Monitoring Station

ISSUE/DATE:	August 18, 2011	BULLETIN NUMBER:	AQ081811
SUBJECT:	Monitoring Station	PRODUCT LINE:	Aquafine UV Equipment
TOPIC:	WIRING UPDATE TO EQUIPMENT WITH THE 41114-1 MONITORING STATION

Snubber Part number 41817

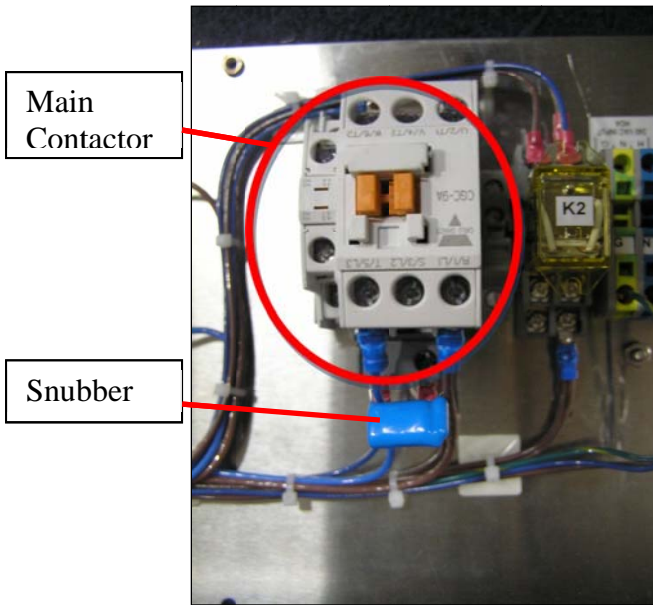
The design change includes the installation of a “snubber” across the coil of the main contractor. The snubber is Aquafine part number 41817 and used to reduce the high voltage spike that can result in damage to the electronics.

Equipment purchased with the Monitoring Station after 8/26/2010 should have the snubber pre-installed at Aquafine. Previous equipment with the Monitoring station should install the snubber in the field.

**3 or 4 pole Main contactor
 Snubber Connected to positions A1 and A2**

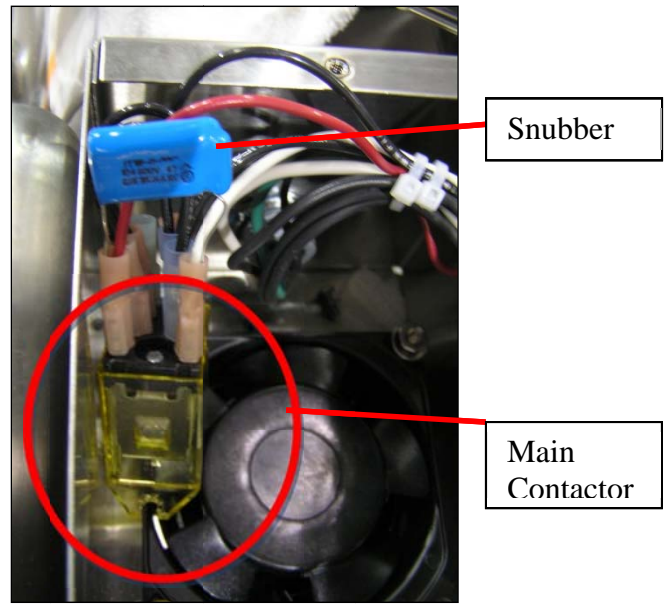
The installation of the snubber will be placed in parallel with the coil of the Main contractor (control relay). Aquafine utilizes many types of main contactors. Please note that there may be other contactor (remote contactor, alarm contactors, etc.) inside the electrical panel. The snubber must be connected to the main contactor which operates the UV lamps.

1. Shut off system, removing all electrical power to prevent personal injury.
2. Locate the main contractor and coil positions. One position of the main contact coil is directly wired to the Monitoring station High Temperature output relay position NO (normally open). The other position of the coil will be wired directly to AC Neutral.
3. Connecting the snubber to the coil contacts of the main contractor.
 - a. The snubber is installed in parallel with the coil contact
 - b. Connection points of snubber will depend upon the contactor type.
